February 20, 2025

**RE: United States Steel Keetac Permit to Mine Tailings Storage Facility Mining Area**

DNR Map 1 - United States Steel Corporation Keetac Basin Mining Area Revisions

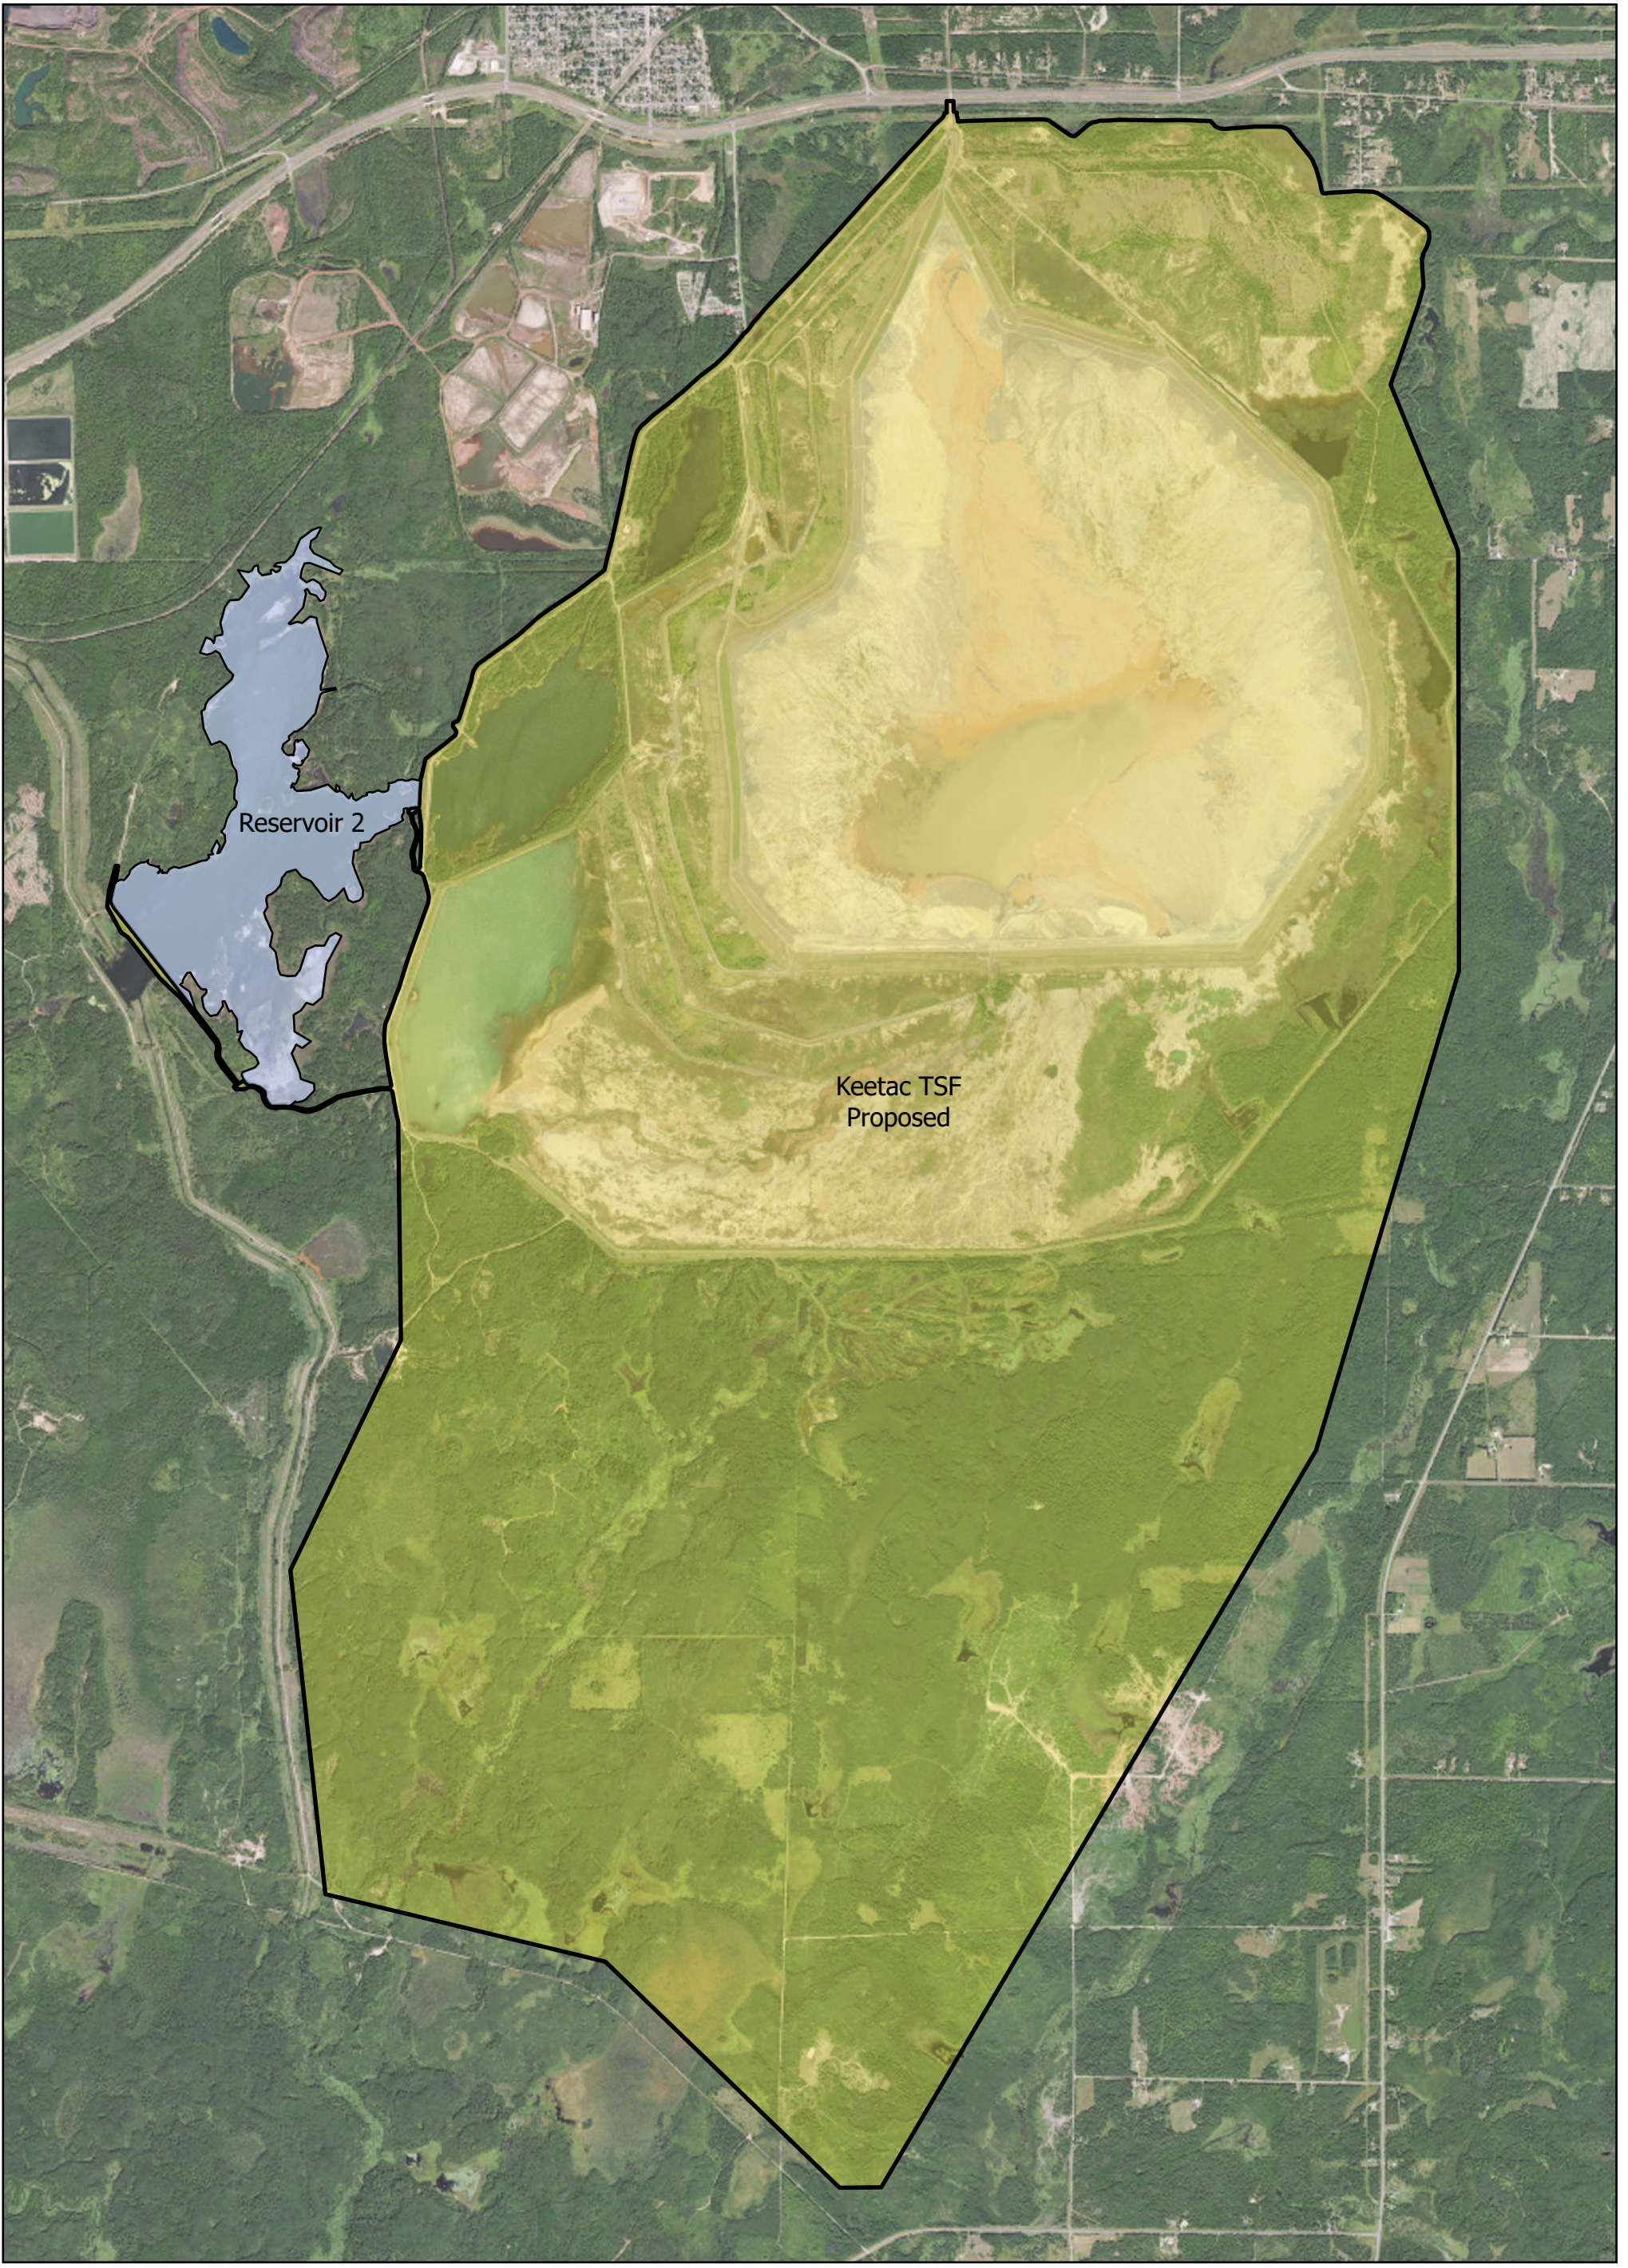
The DNR concurs with a majority of the June 7, 2024 GIS package representation of the Mining Area (DNR Map 1). Two exceptions are as follows.

1. Mesabi Chief 2 Dams. The DNR will not include the Mesabi Chief 2 Dams because this area, although owned by US Steel, is not a part of the mining operations at Keetac. This was discussed and agreed upon with Keetac staff on December 6, 2024. DNR Map 1 was revised to remove this area as compared with the June 7, 2024 GIS package.
